Ref: 29011.00

Re: MDP and Site Plan Phase 1 Comments
Silo Ridge Resort Community
Amenia, NY

On behalf of our client, Silo Ridge Ventures, LLC., "the Applicant", VHB Engineering, Surveying and Landscape Architecture, P.C. (VHB) offers the following responses to your comments dated October 17, 2014 (numbered in accordance with your letter).

Not Approved for Construction
 Drawing Title
General Plan 2

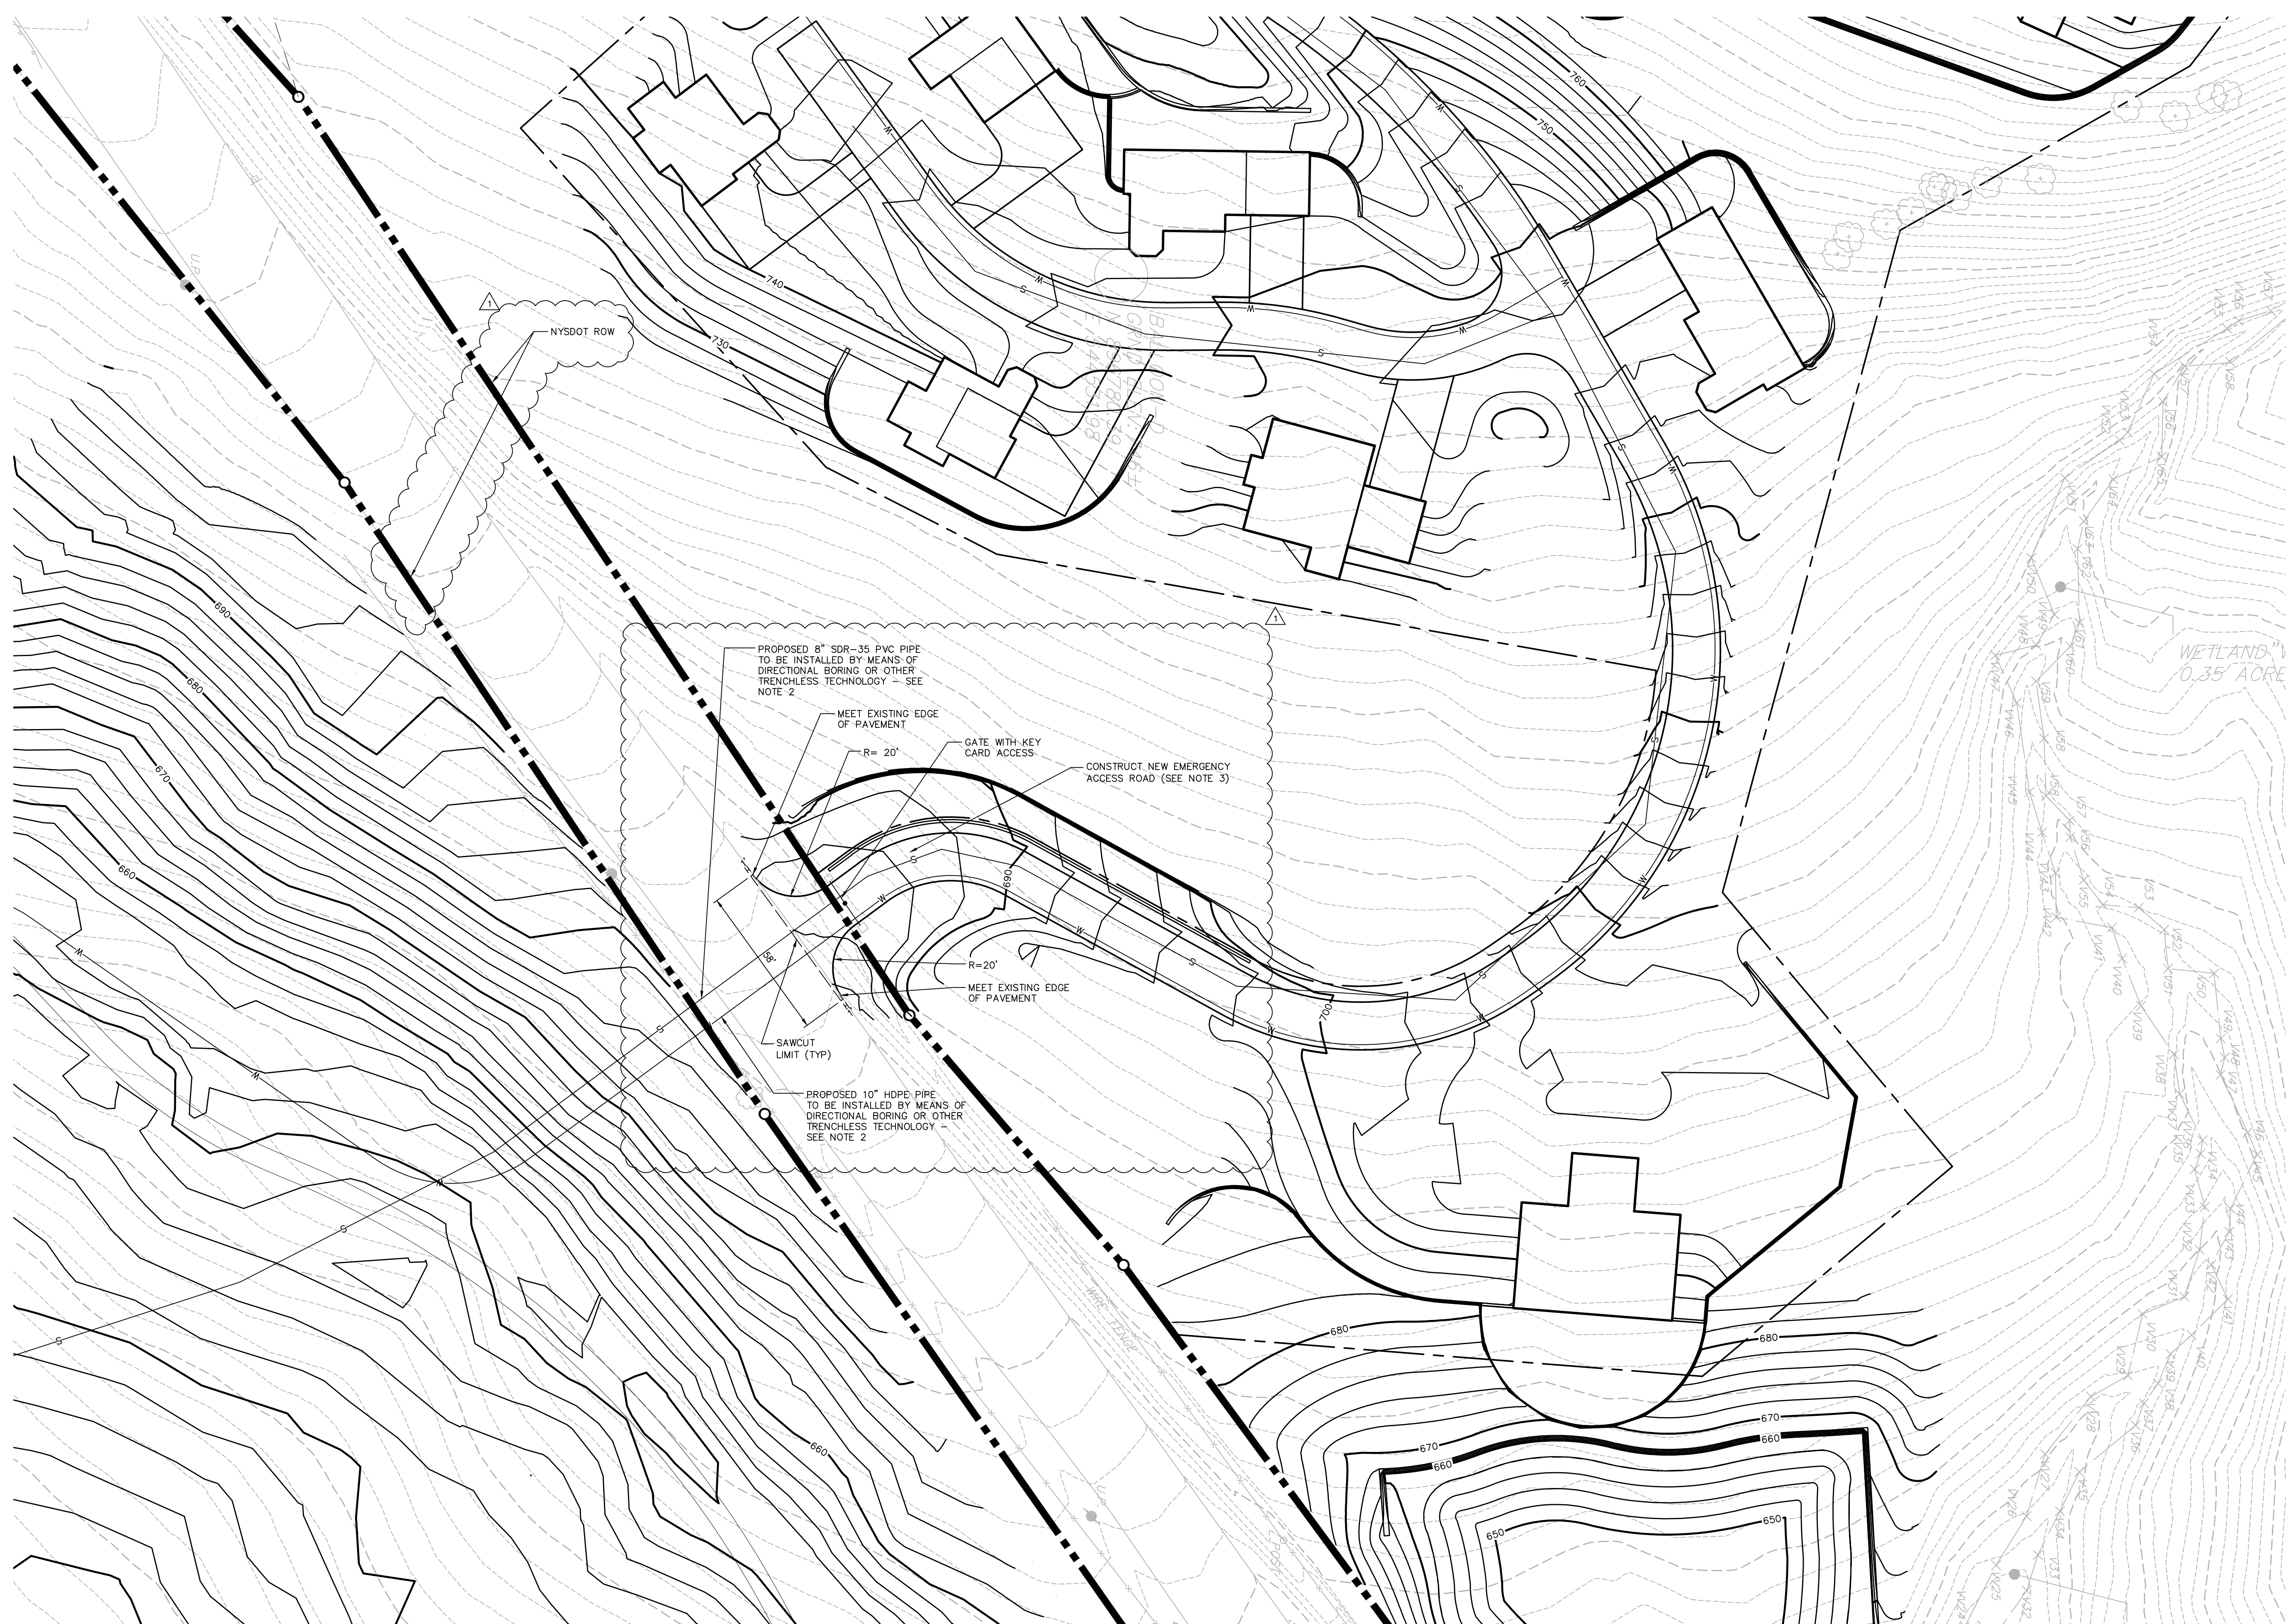
3. Comment: At one time, it was understood that a fill operation was planned within the right-of-way at either side of the main entrance. This is not evident on the plans. A confirmation is requested.

Response: The area of fill proposed within the right-of-way is adjacent to the main entrance on Route 22, as shown in plan view on drawing GP-1, General Plan 1 and GP-2, General Plan 2, dated January 8, 2015. Cross sections have been taken at four locations at the main entrance, as shown on drawing

Not Approved for Construction
Drawing Title
General Plan 3

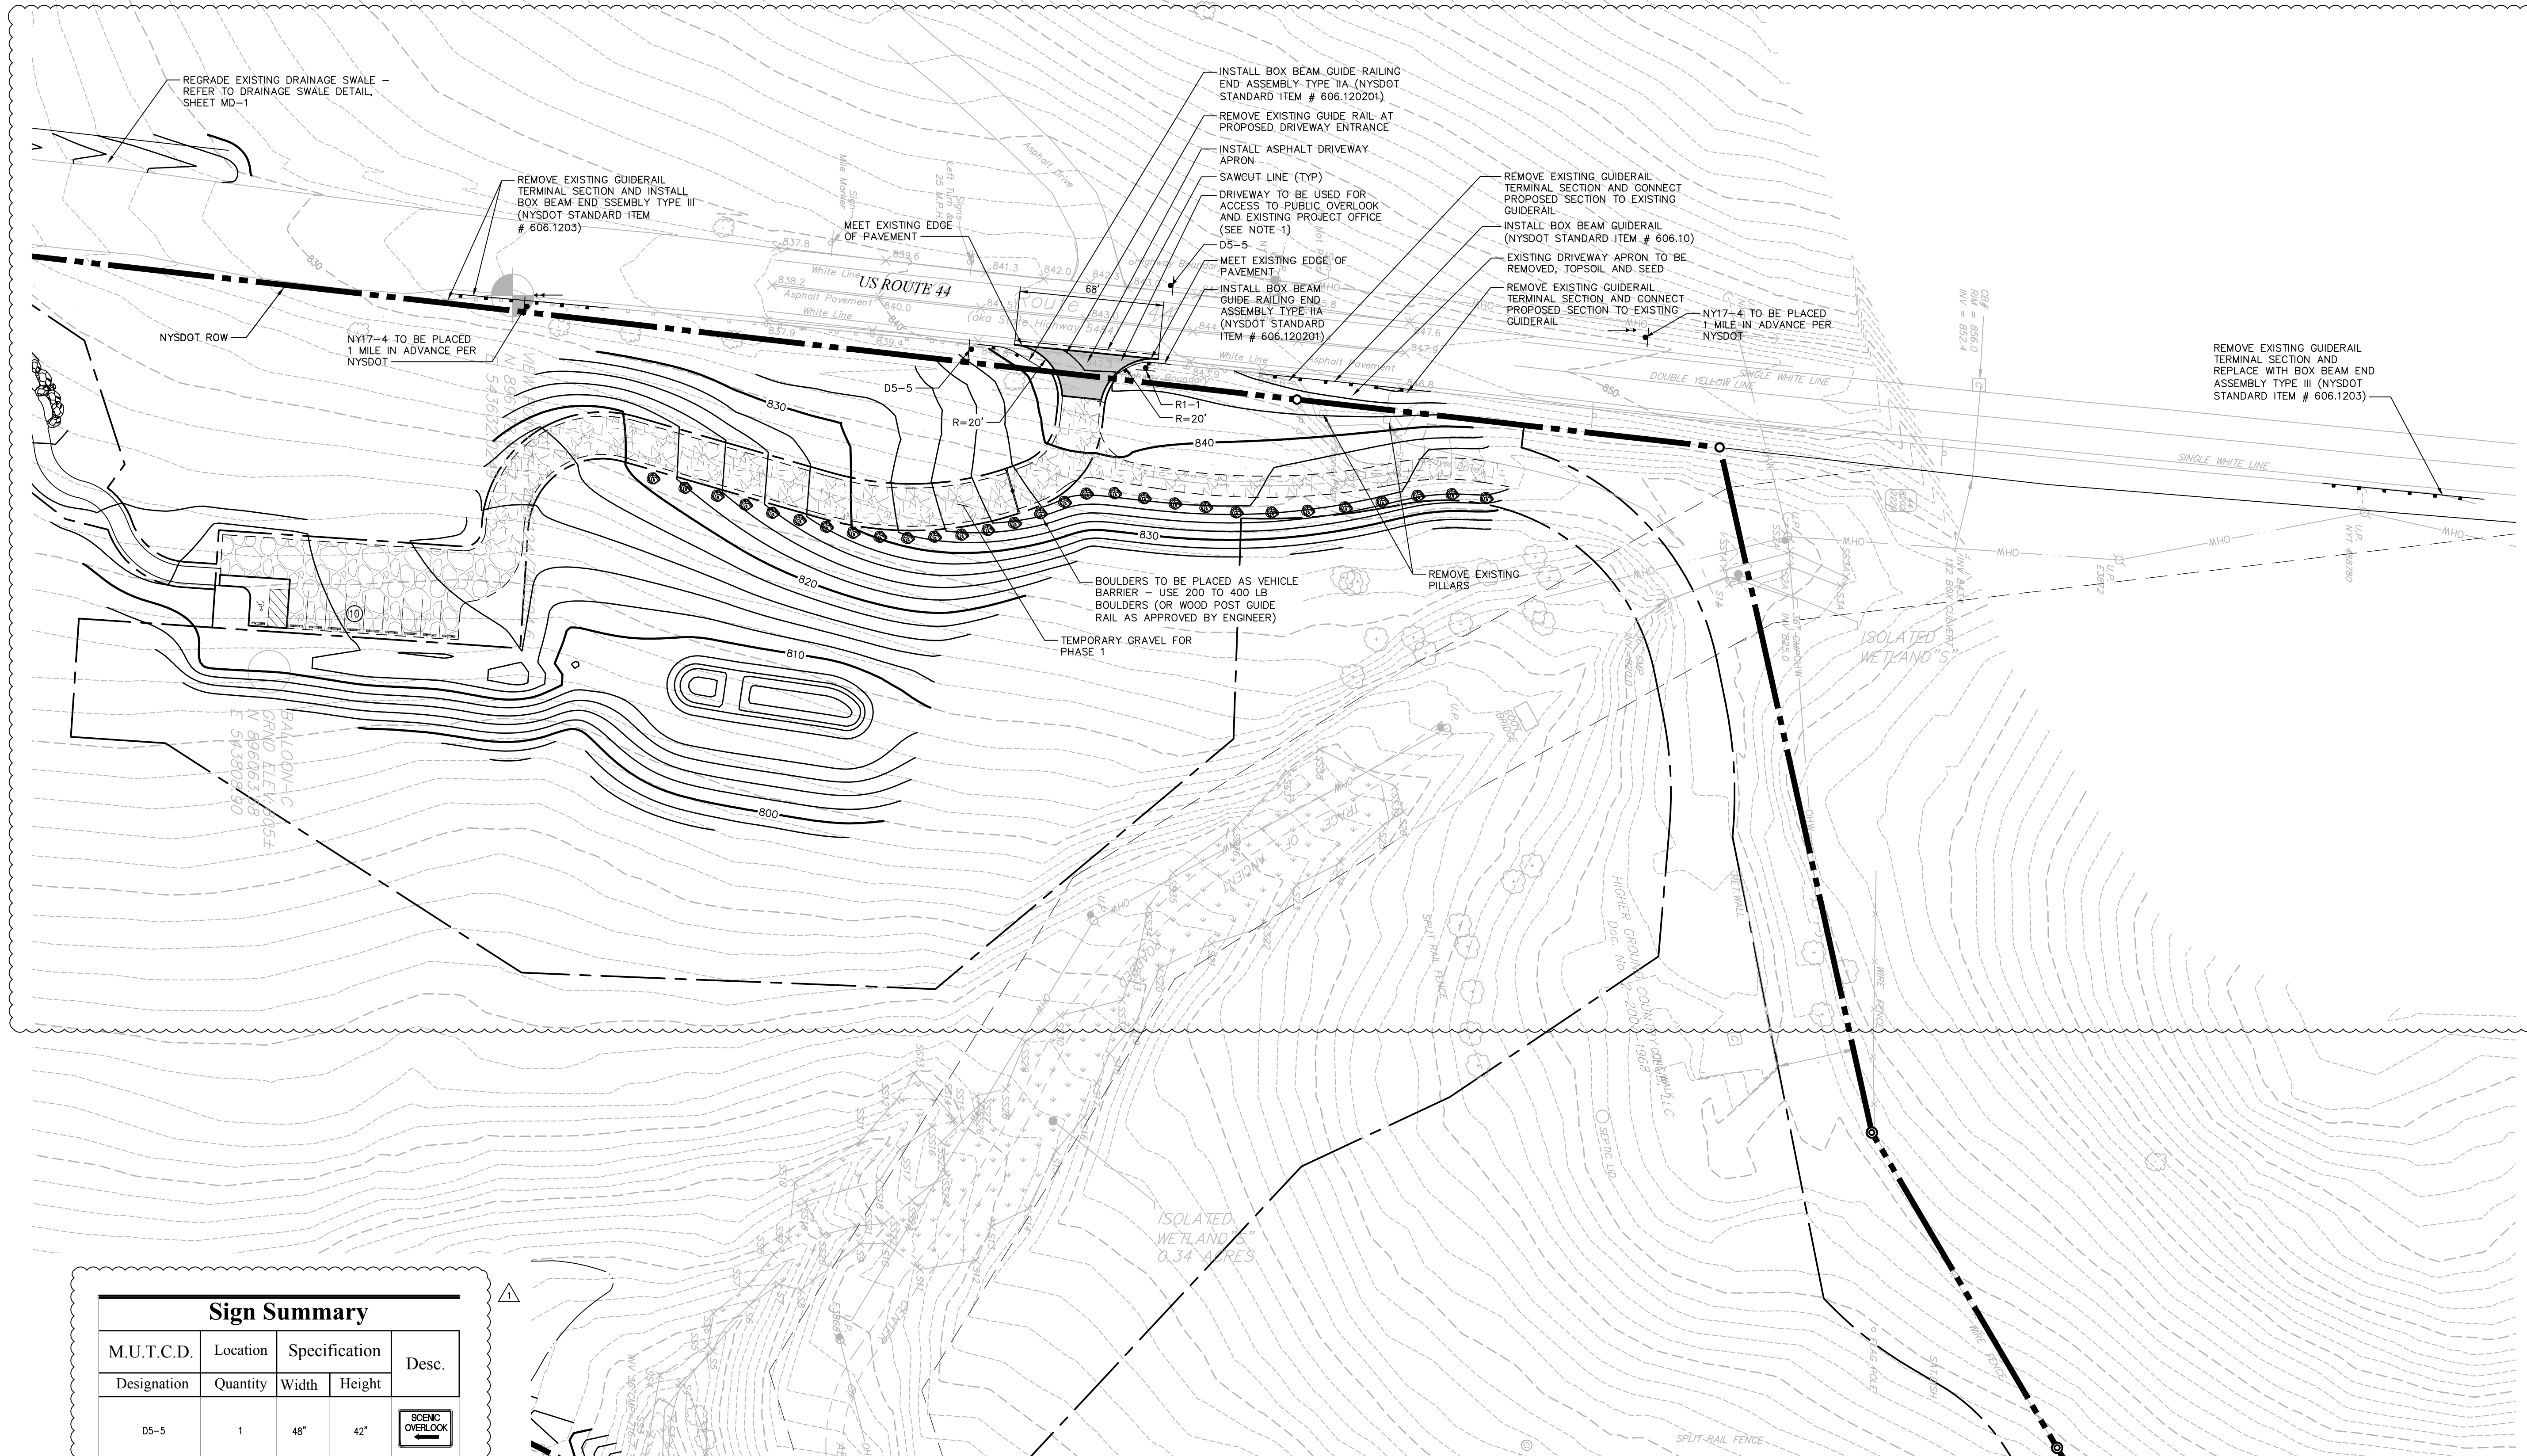
6. Comment: The proposed emergency entrance must not be a "Boulevard Entrance". It should be simply planned accommodating the design vehicle. A locked and gated access must clearly be shown on the plans. This emergency entrance must not be available for daily use of development occupants.

Response: The emergency entrance on Route 44 has been redesigned as requested and is shown as "gate with key card access for emergency access only" on the revised plans (please refer to Drawing GP-3, dated January 8, 2015).
